February 26, 2014
L-2014-041

Re: Turkey Point Unit 3 and Unit 4
Docket Nos. 50-250 and 50-251
Florida Power and Light Company's Turkey Point Units 3 and 4, Second Six-Month Status Report in Response to March 12, 2012, Commission Order Modifying Licenses with Regard to Requirements for Mitigation Strategies for Beyond-Design-Basis External Events (Order Number EA-12-049)

Second Six Month Status Report for the Implementation of Order EA-12-049

4 Changes to Compliance Method

OIP Attachment 4
Conceptual Sketches and Modifications
Modification No. 6 (Unit 3 Shown, Unit 4 similar)

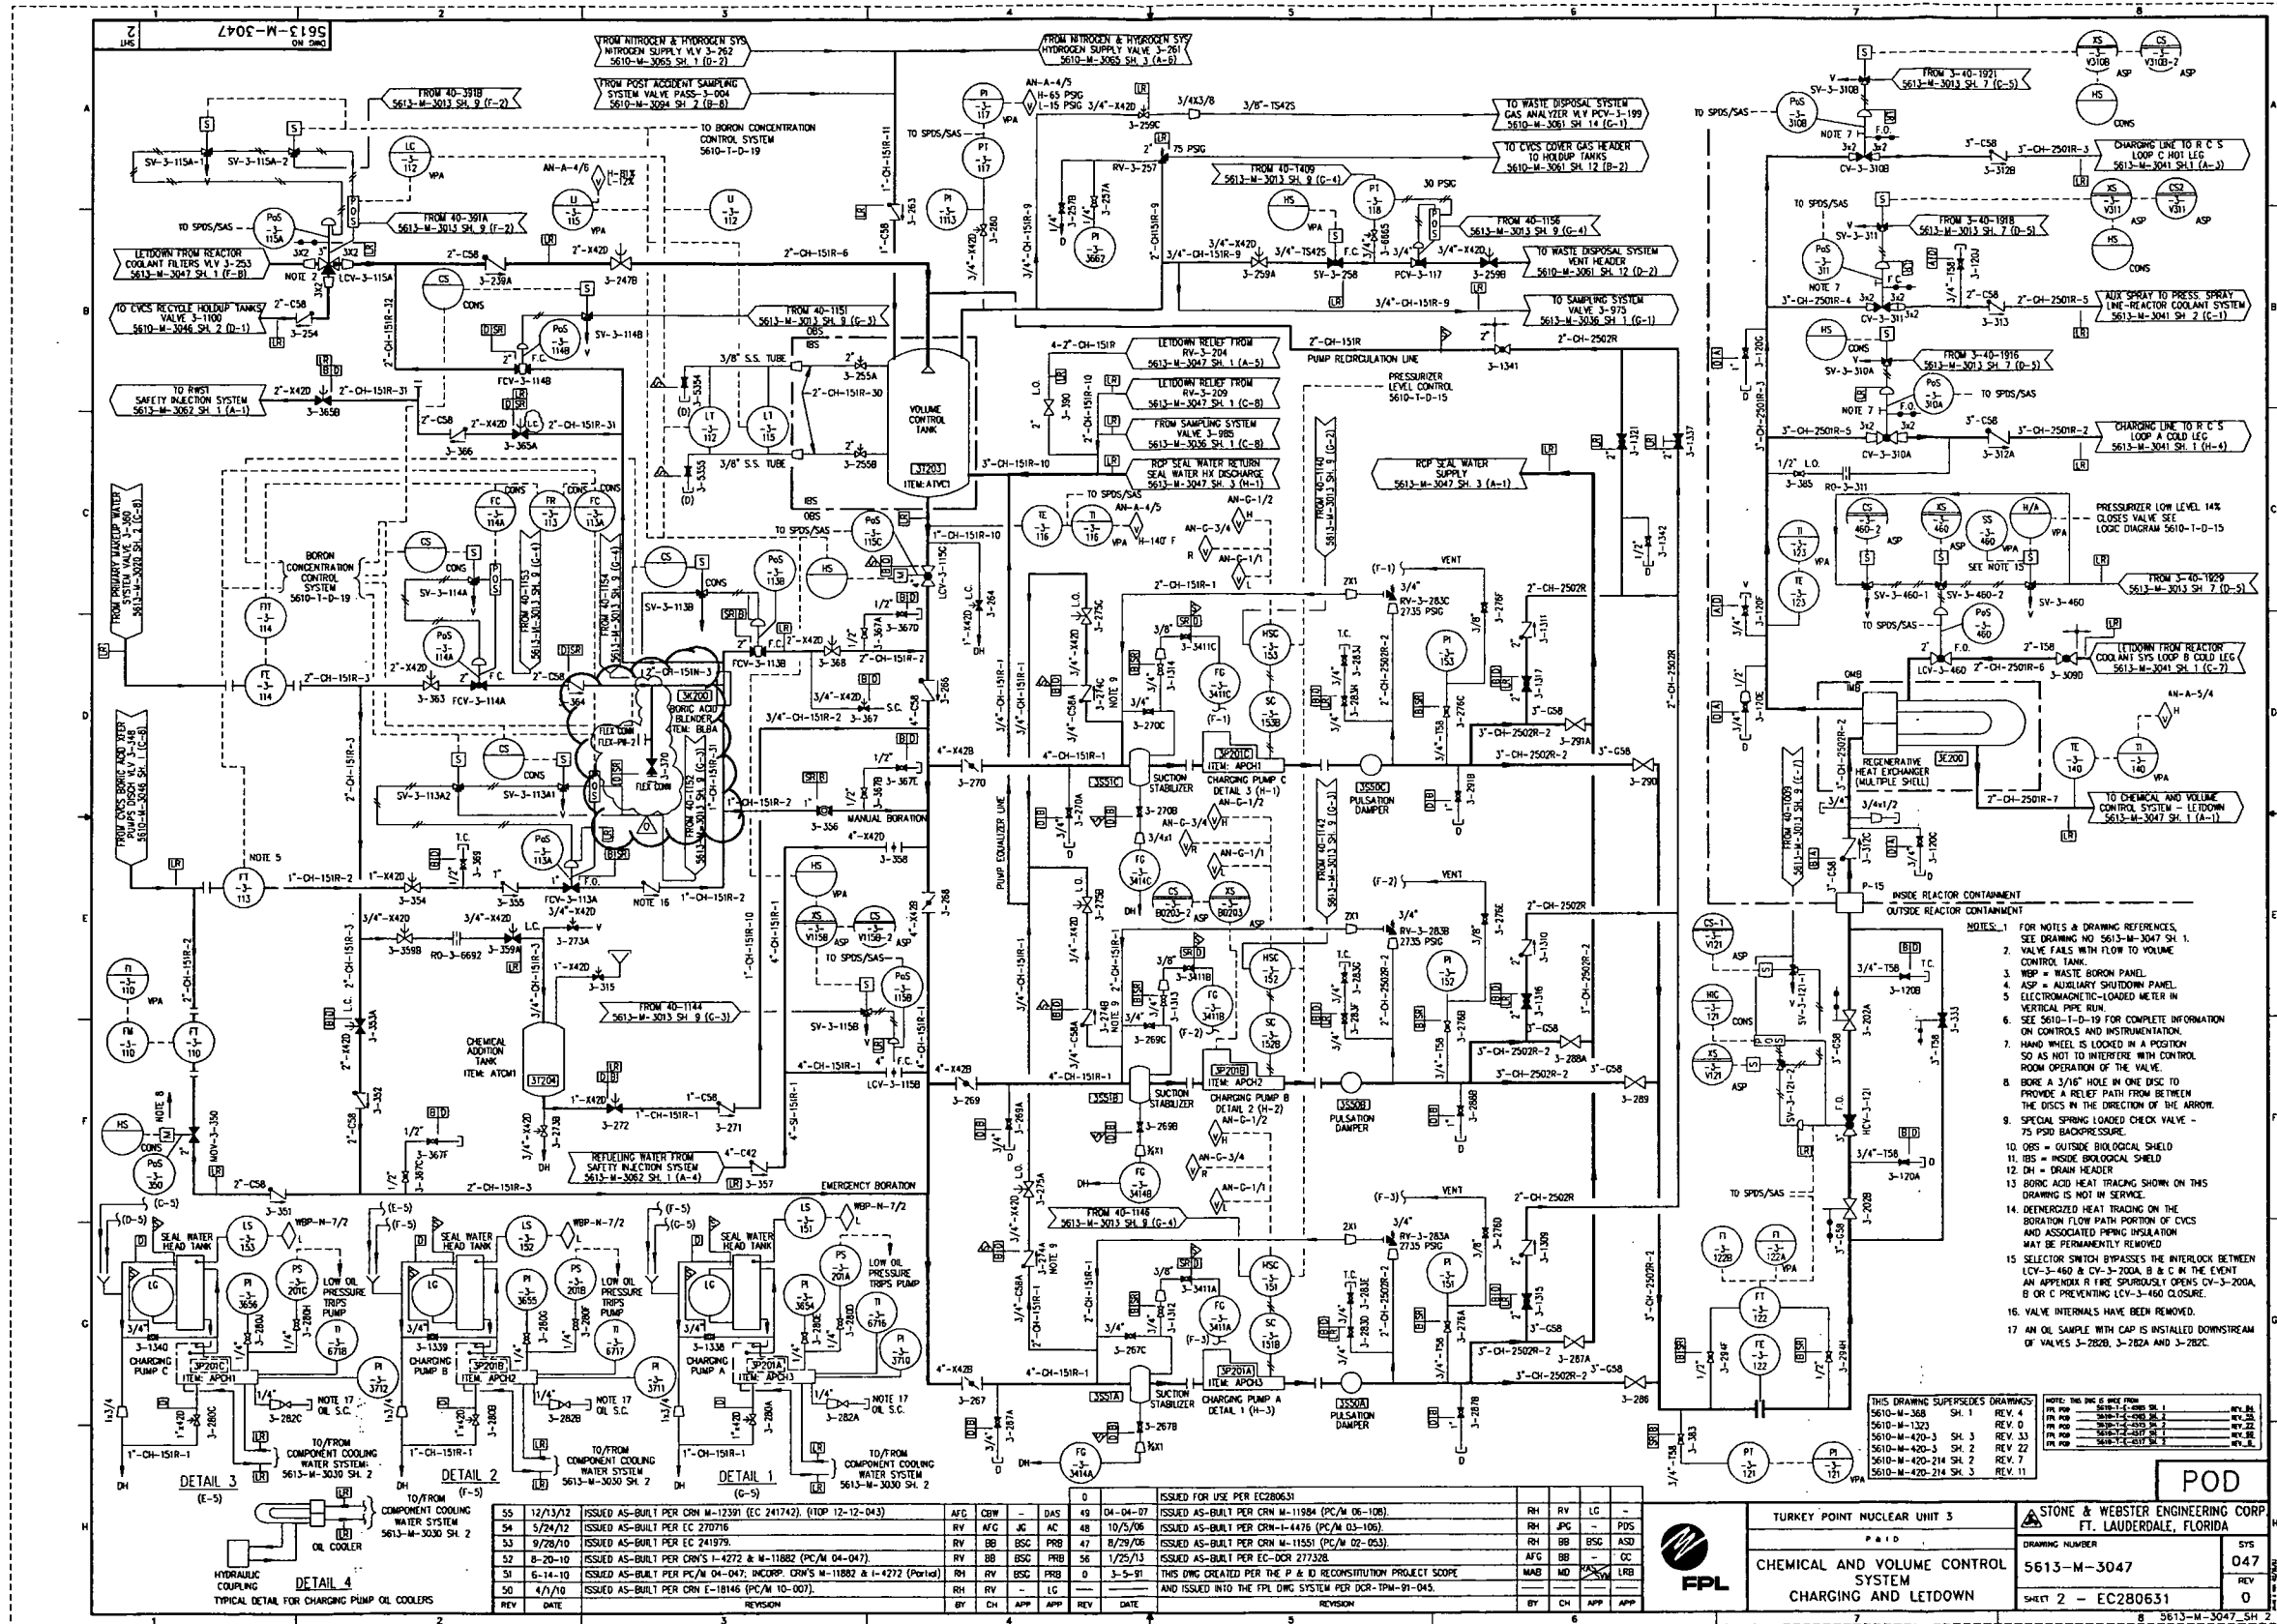
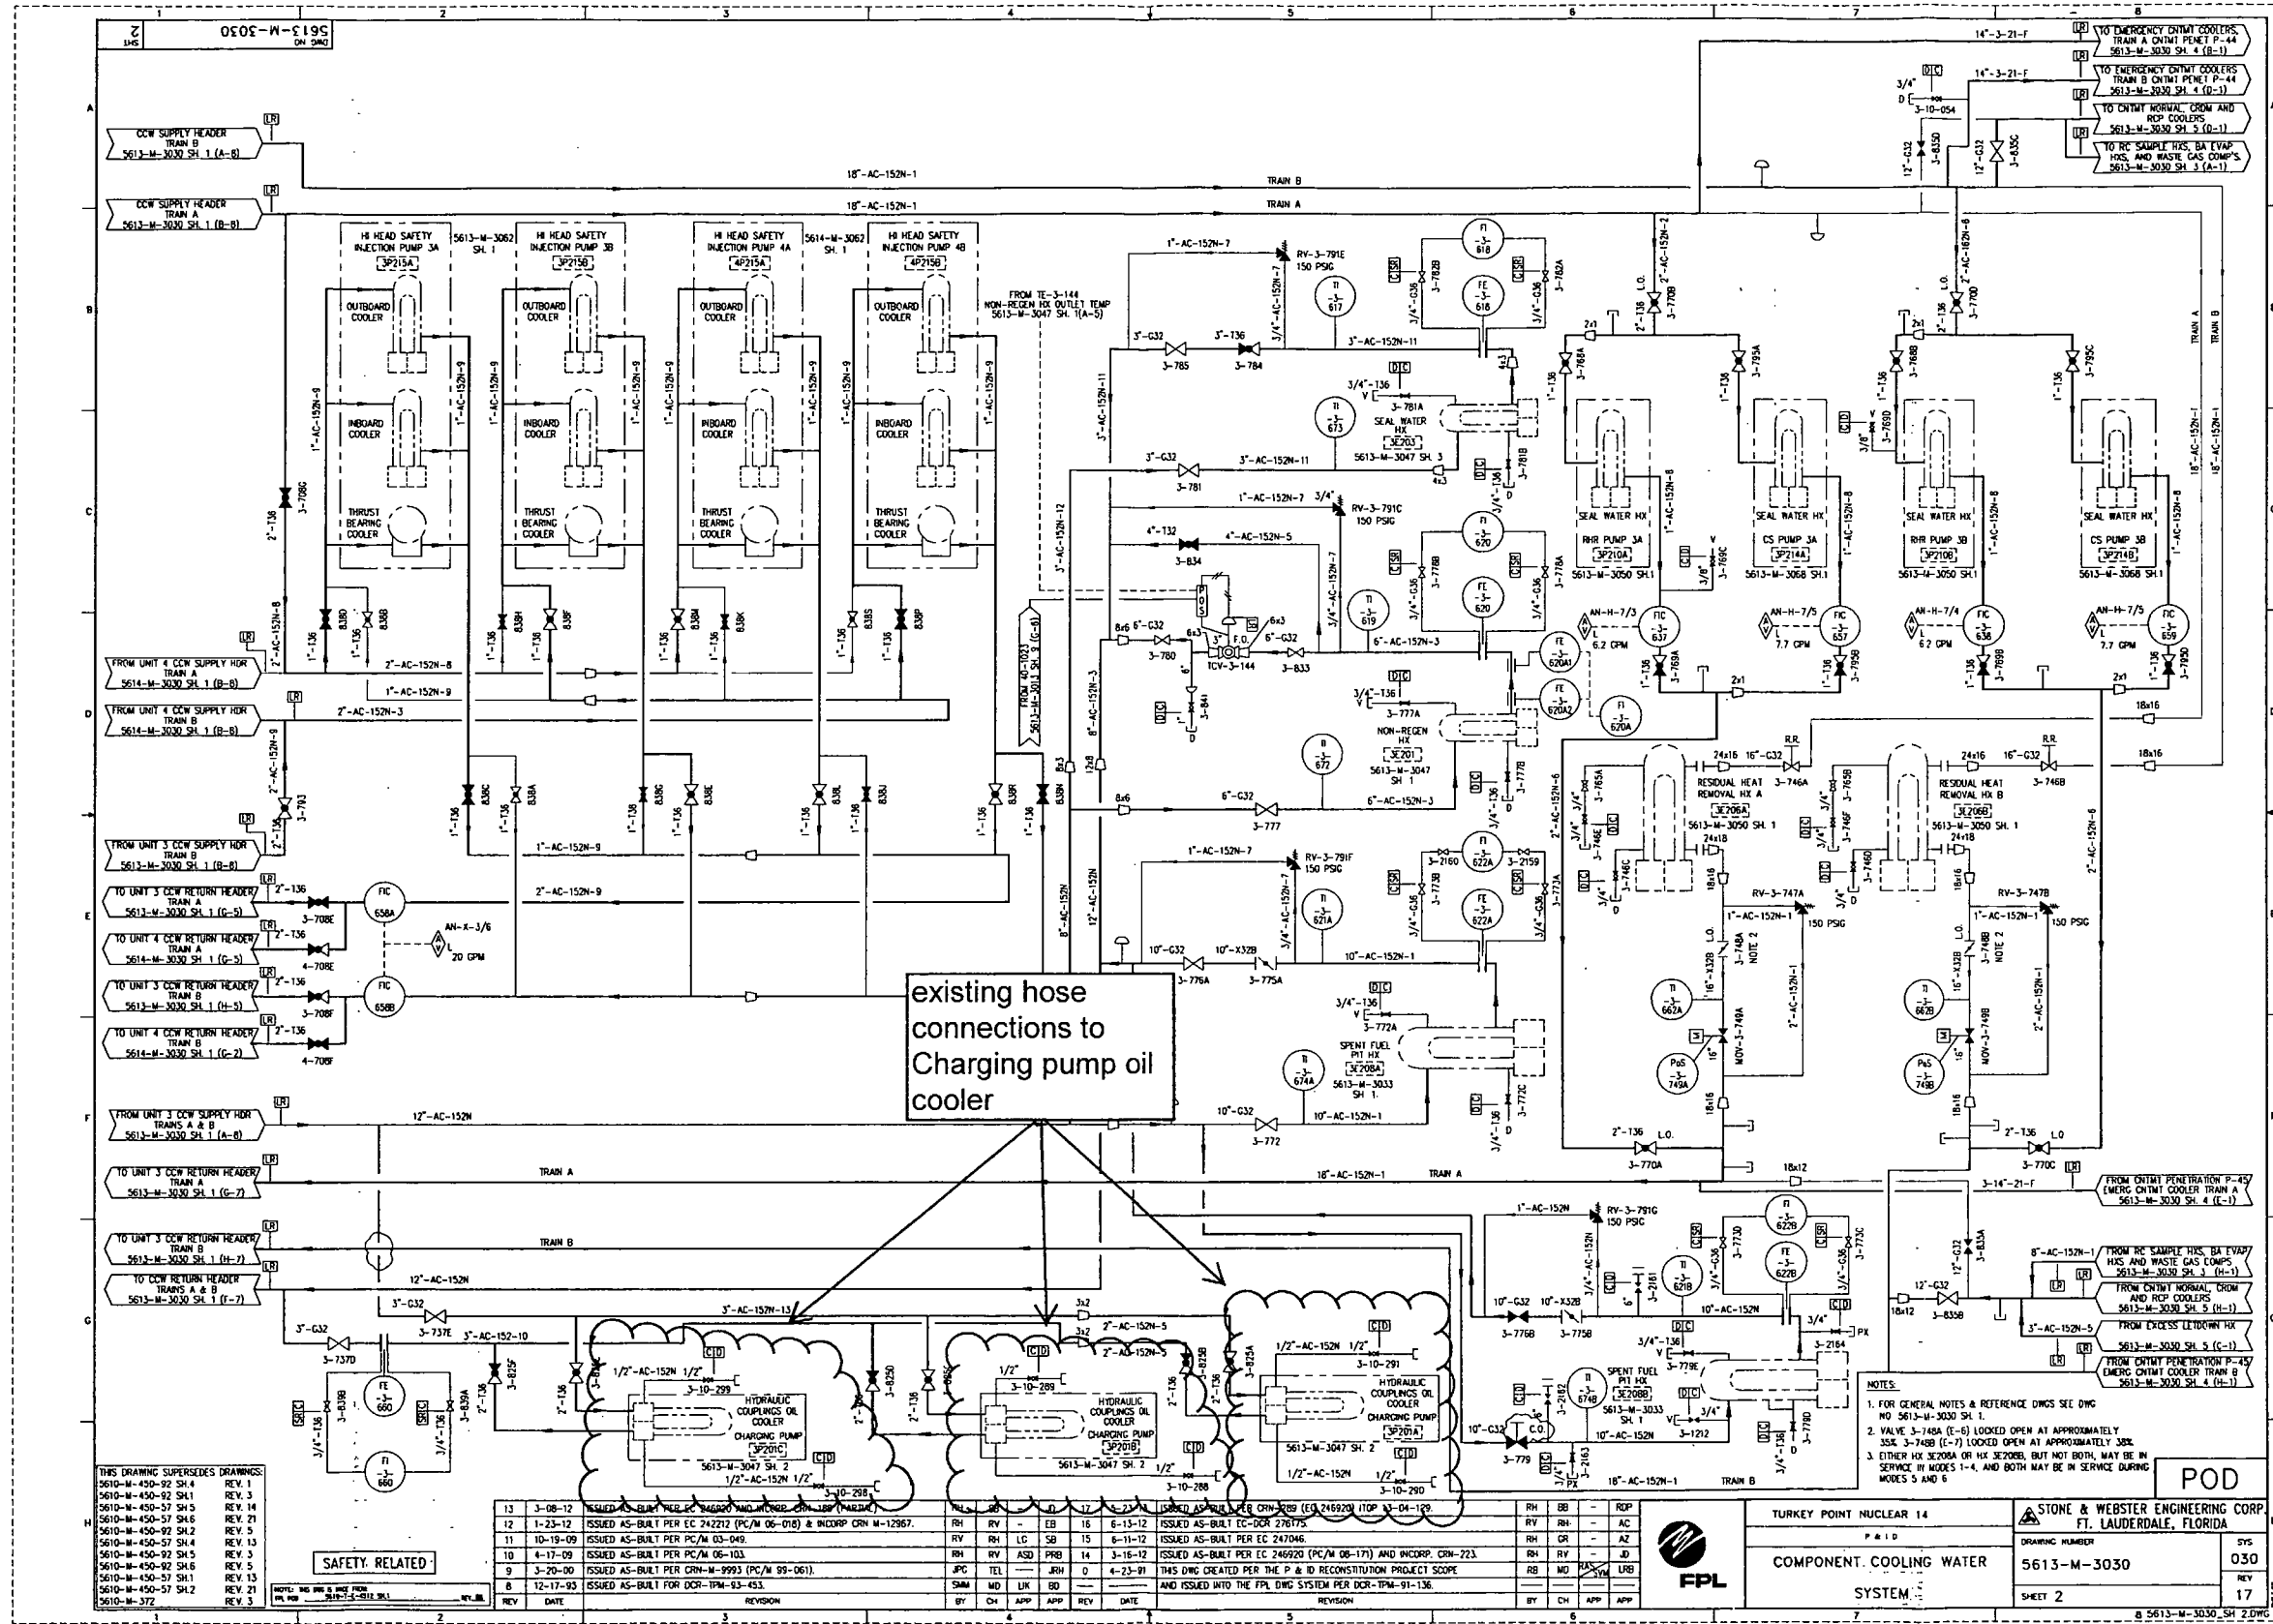
Modification No. 6, Install isolation valve and hose connections in Refueling Water Storage Tank (RWST) Manhole covers.

The Overall Integrated Plan submittal (Reference 1, Attachment 4) included a sketch showing a new hose connection point to the Refueling Water Storage Tank (RWST) manway cover for use during Phase 2 (Modification No. 6). Makeup to the RWST would only be required during modes 5 and 6. Adding makeup water directly to the RWST would require additional portable equipment for boron mixing. Therefore, a new permanent hose connection will be provided at the primary makeup water supply line to the boric acid blender. This will allow normal boron mixing using well water supplied by a hose from the SG FLEX pump and boric acid from boric acid storage tanks (BAST) utilizing the boric acid transfer pumps. Makeup to the BAST will be provided by supplying well water from the SG FLEX pump to the boron batching tank. Discharge from the boric acid blender goes directly to the charging pump suction line for makeup to the RCS. As a backup, blended flow could be provided to the RWST if needed. The hose to the primary water connection from the SG FLEX pump will also supply cooling water to the existing hose connections on the Charging Pump oil coolers. A revised modification No. 6 conceptual sketch has been provided in Attachment 3. The new connection points are within robust structures, and the systems to be used for tie-in and delivery are seismically analyzed safety related systems or will be shown to be robust. This change will not affect the strategy since the charging pumps are already credited to provide reactor coolant system inventory makeup during Phase 2.
